Access Compliance Report Public Rights-of-Way (Curb Ramps)

Intersection ID: 10015096	Main Street: N_SHARON_AMITY_RD	Cross Street: N/A	Location: NE
ADA ID: 81C4FE357A39	Ramp Type: Perp	Initial Pass/Fail: Fail	Overall Compliance: No Severity Score: 26.25

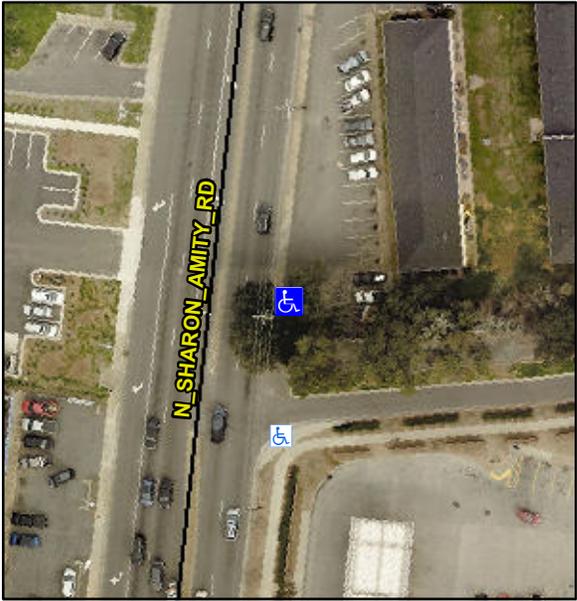
PROW/ADA:
R304.2.2, R304.5.3

Compliance	Description	Data	Compliance	Description	Data
N/A	Ramp Length (in)	66.0	No	Ramp Slope (%)	20.1
Yes	Ramp Width (in)	56.0	No	Ramp XSlope (%)	2.9
N/A	Flare Type LT	N/A	N/A	Flare Type RT	N/A
N/A	Flare Slope LT (%)	N/A	N/A	Flare Slope RT (%)	N/A
N/A	Flare Traversable LT?	N/A	N/A	Flare Traversable RT?	N/A
N/A	Landing Length (in)	N/A	N/A	DWS Provided?	N/A
N/A	Landing Width (in)	N/A	N/A	DWS Contrast?	N/A
N/A	Landing Slope (%)	N/A	N/A	DWS Length (in)	N/A
N/A	Landing X Slope (%)	N/A	N/A	DWS Full Width?	N/A
N/A	Landing Curb? (Y/N)	N/A	N/A	DWS Offset (in)	N/A
N/A	Shared Landing?	N/A			
N/A	Gutter Ponding?	N/A	N/A	Gutter Slope (%)	N/A
N/A	Gutter Lip Ht (in)	N/A	N/A	Gutter X Slope (%)	N/A
N/A	Painted X Walk1?	No	N/A	Painted X Walk2?	N/A
	X Walk 1 Direction	To S		X Walk 2 Direction	N/A
N/A	X Walk 1 Width (in)	N/A	N/A	X Walk 2 Width (in)	N/A
	X Walk 1 Slope (%)	1.5		X Walk 2 Slope (%)	N/A
	X Walk 1 X Slope (%)	0.3		X Walk 2 X Slope (%)	N/A

Possible Solutions:
Remove & Replace Entire Ramp.
